# VILLAGE OF KINGS CONTRIVANCE

# THE PINES AT DICKINSON

**COLUMBIA THE PINES AT DICKINSON**  
 VILLAGE OF KINGS CONTRIVANCE  
 SECTION 2 AREA 3  
 PARCEL 'G'  
 "REVISED SITE DEVELOPMENT PLAN"  
 CULVERT CONSTRUCTION DRAWING  
 SHEET 14 OF 17

ELECTION DISTRICT 6, HOWARD COUNTY, MARYLAND  
 DATE: December 10, 2021  
 SCALE: 1"=10'

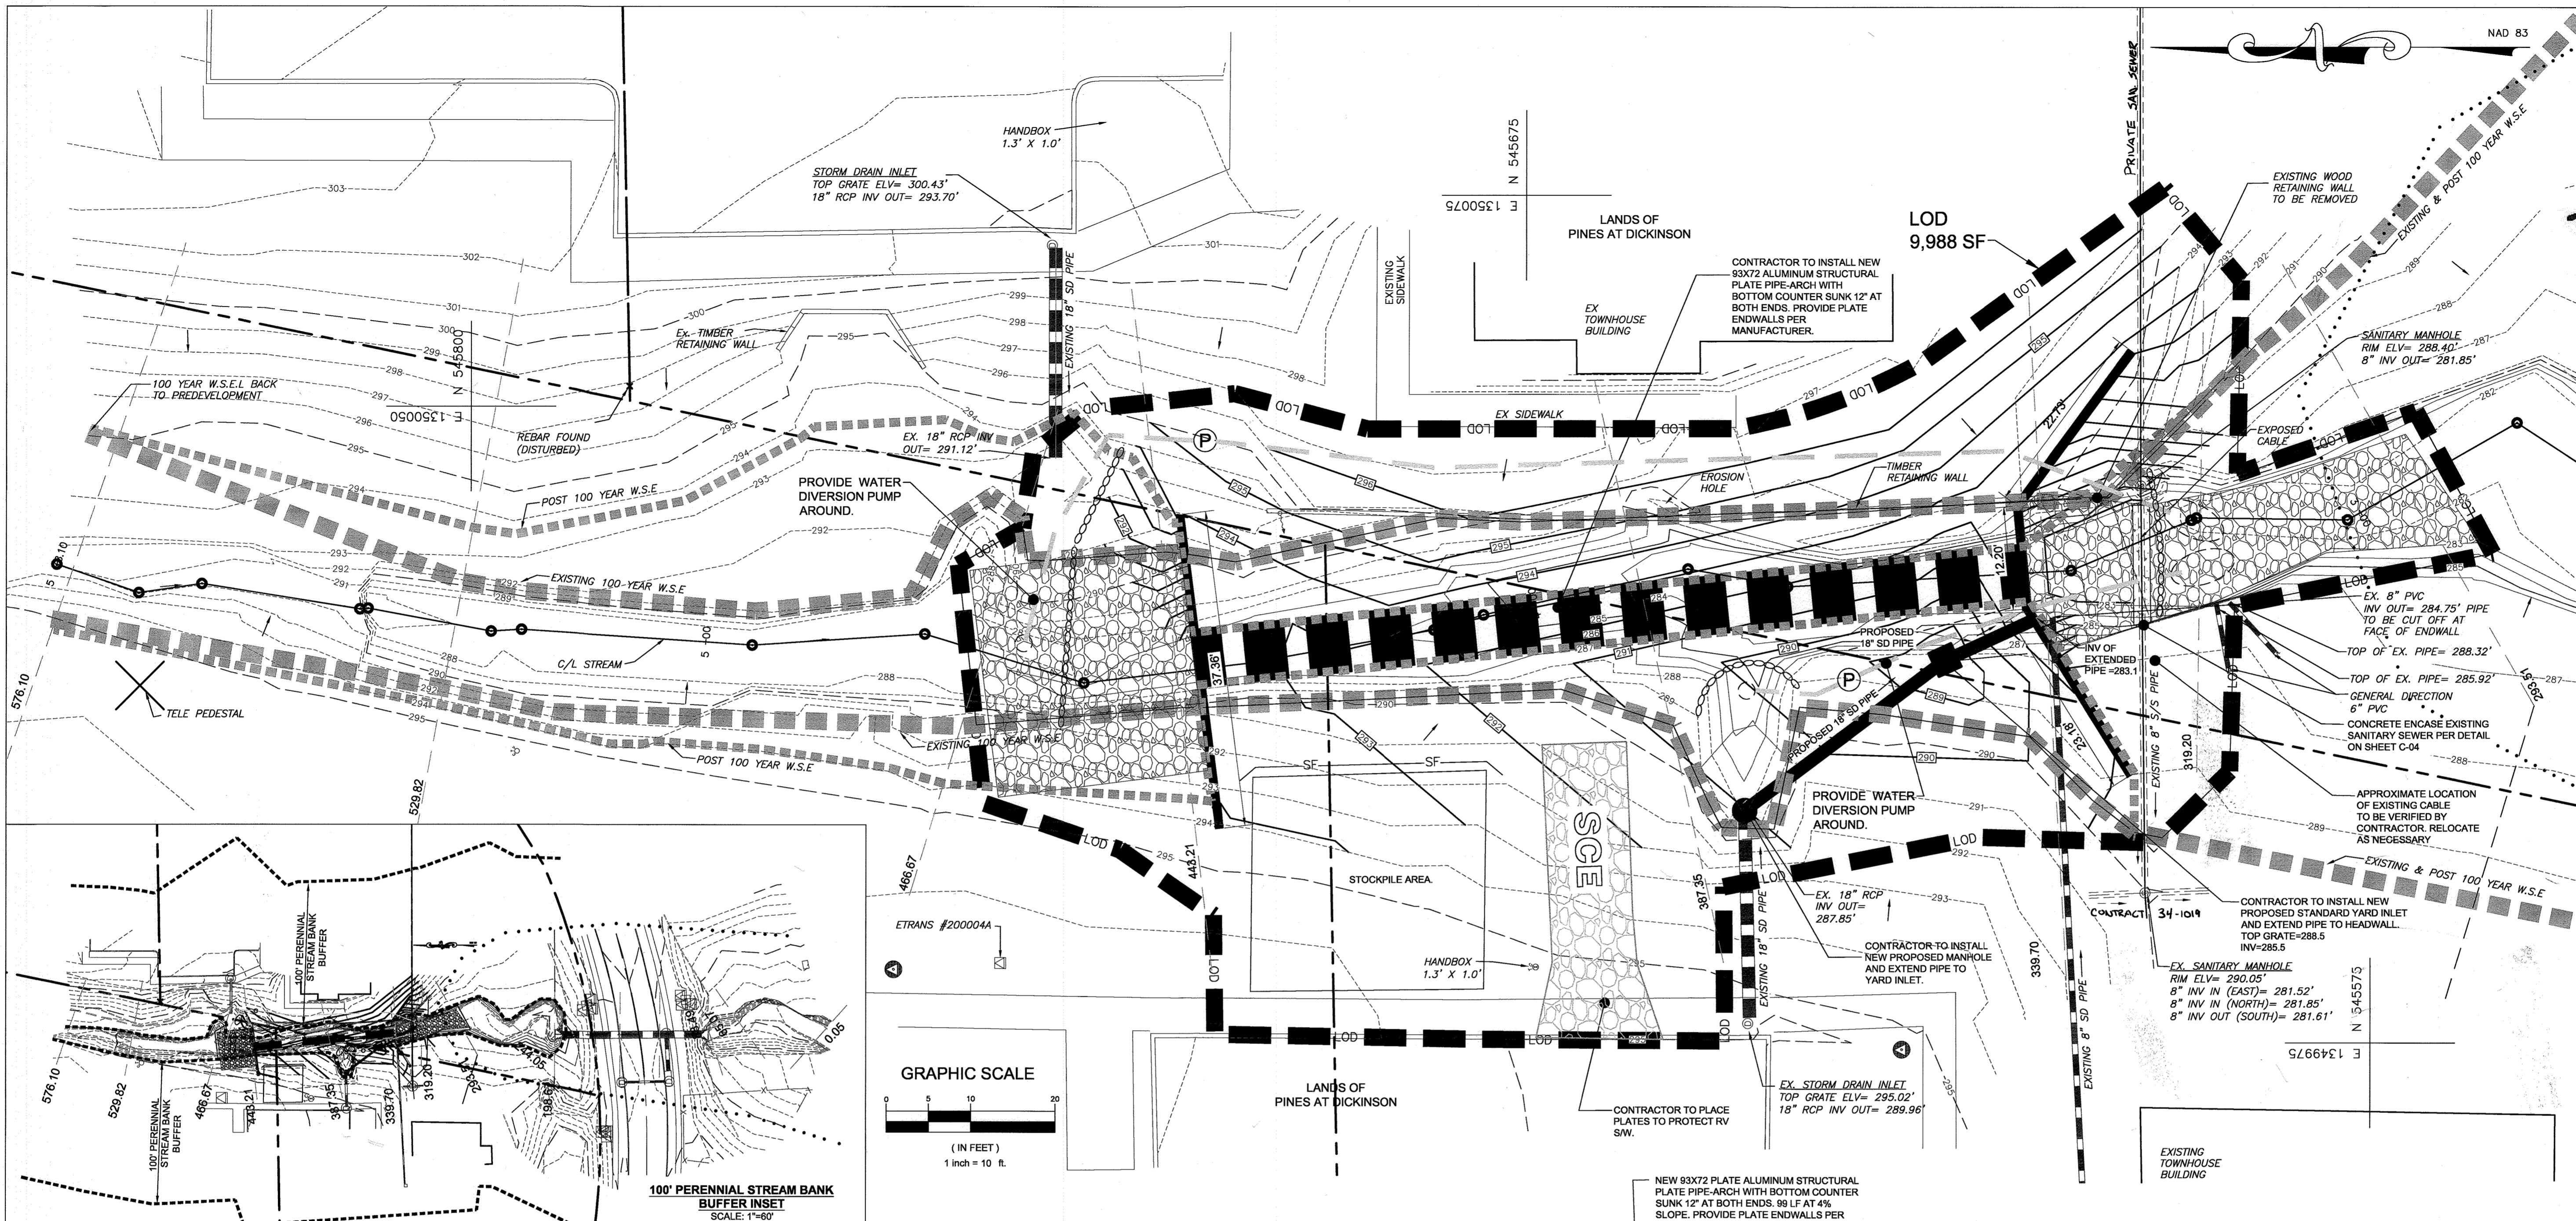
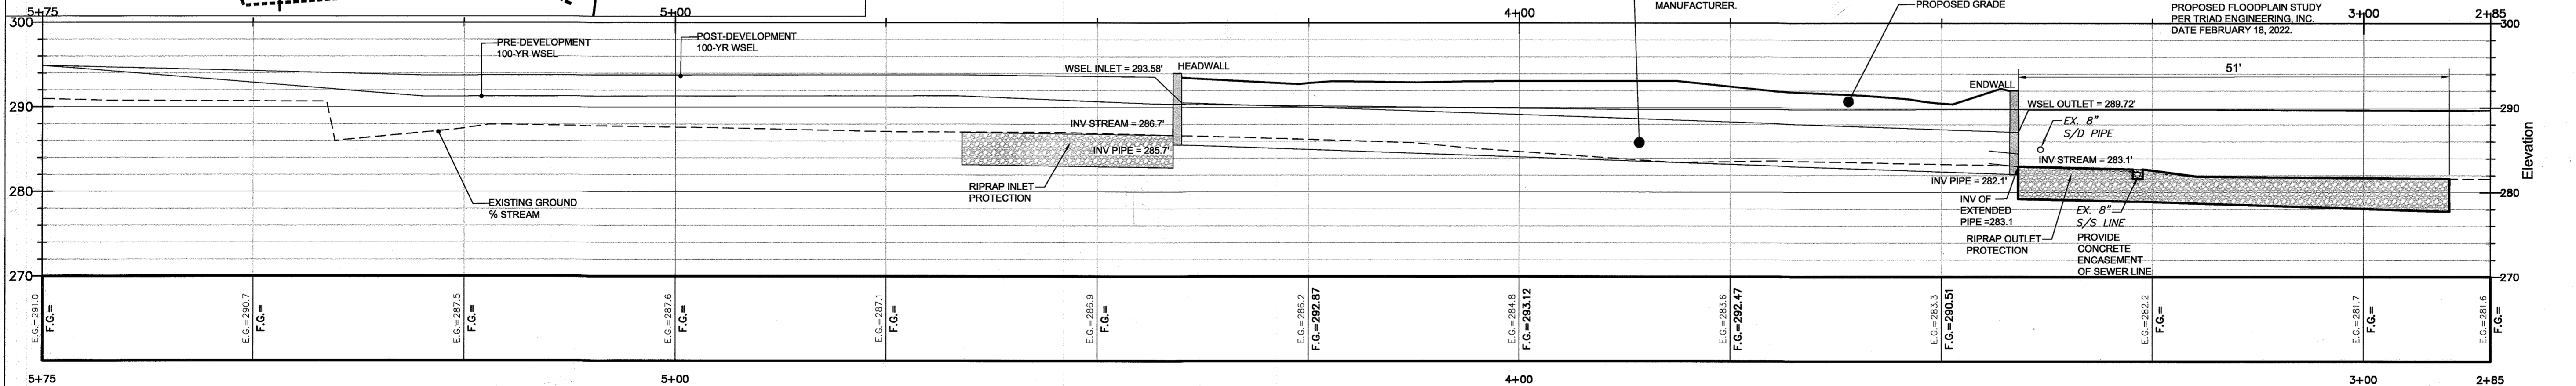
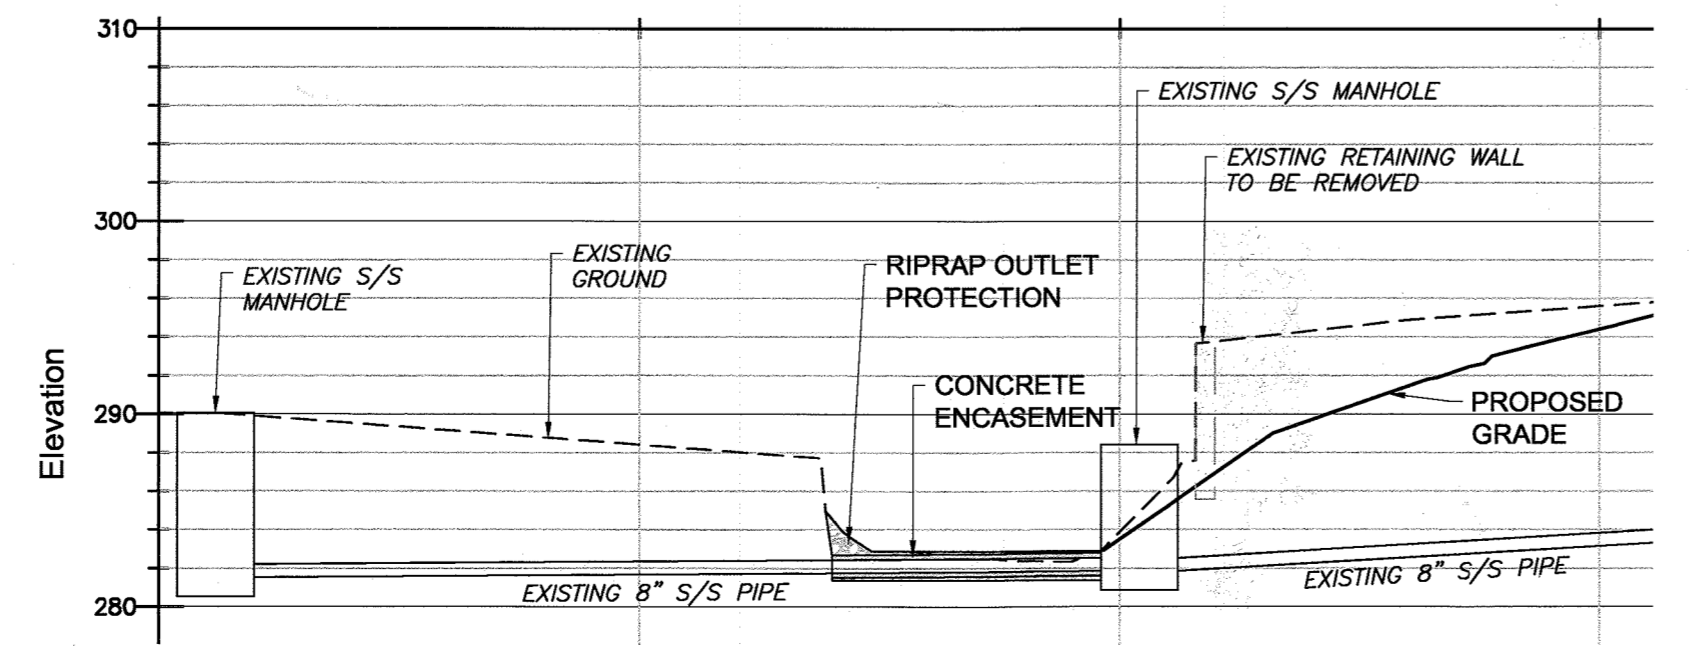
**THE PURPOSE OF THE RETAINING WALL REPLACEMENT IS DUE TO IT FAILING AND AT RISK OF COMPLETE FAILURE. THE METHOD OF REPLACE/ REPAIR IS TO INSTALL CULVERT/ STREAM CHANNEL TO ELIMINATE NEED FOR WALL.**

- THIS ALTERNATIVE COMPLIANCE REQUEST TO SECTION 18.116(a)(2)(iii) OF THE SUBDIVISION AND LAND DEVELOPMENT REGULATIONS IS FOR DISTURBANCE TO A 100-FOOT STREAM BANK BUFFER TO REPLACE A FAILING RETAINING WALL AND TO PERFORM RELATED REPAIRS WITHIN THE BUFFER. THE LIMITS OF DISTURBANCE IS 9,988 S.F. THE SUBJECT PROPERTY IS ZONED NT (NEW TOWN) AND IN ACCORDANCE WITH SECTION 125.0.G.1 OF THE ZONING REGULATIONS, PLANNING BOARD REVIEW AND APPROVAL IS REQUIRED.
- DPZ FILES: FDP-178-III, SDP-82-051, PLAT NO. 6885, F-61-089, 14P-22-101
- MDE WETLANDS AND WATERWAYS PERMIT: 201961376/19-NT-3200
